Service Bulletin

Subject: Bulletin No: 09-038/07

POWER RETRACTABLE HARDTOP - DIFFICULT TO OPEN / CRUNCH NOISE WHEN OPENING

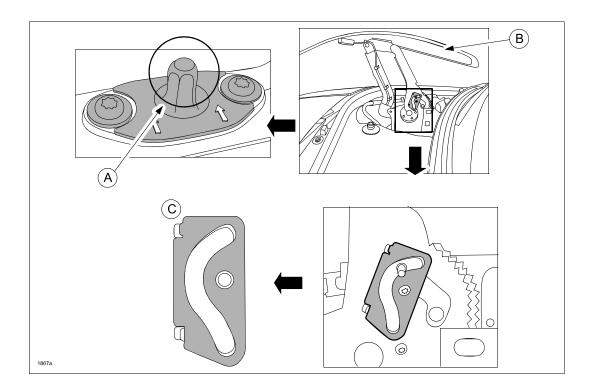
Some vehicles may experience that when trying to open (lower) the Power Retractable Hardtop (RHT), the RHT exhibits a crunching noise and has difficulty opening from the fully closed (up) position.

The clearance between the male wedge (A) on the vehicle body and the receiver on the deck (B) is too tight. As a mass-production change, the shape of the male wedge (A) has been changed. Customers having this concern should have their vehicle repaired using the following repair procedure. The male wedge (A) and both left and right cam plates (C) will need to be replaced.

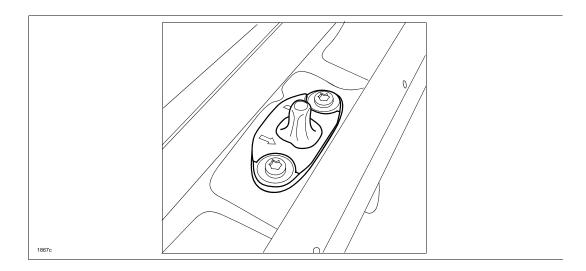
3. Replace the existing male wedge with a modified one. Apply LOCTITE® to screws. *Torque: 35-53 in.lbf (4-6 N.m)*

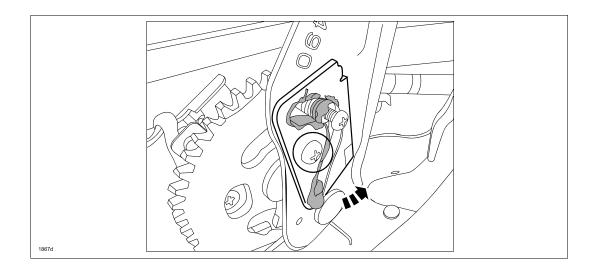
- 4. Replace left and right cam plates one side at a time with modified ones.
 - a. Remove the rear most push clip and pull back the side shelf to access the cam plate.
 - b. Remove screw attaching cam plate to hinge.
 - c. Rotate cam plate outward from screw end to disengage retainers.
 - d. Insert new cam plate retainers into hinge. Install screw using LOCTITE®.

Torque: 26-32 in.lbf (3.0-3.7 N.m)

e. Apply Krytox grease (sourced locally) to the roller guide in the cam plates.
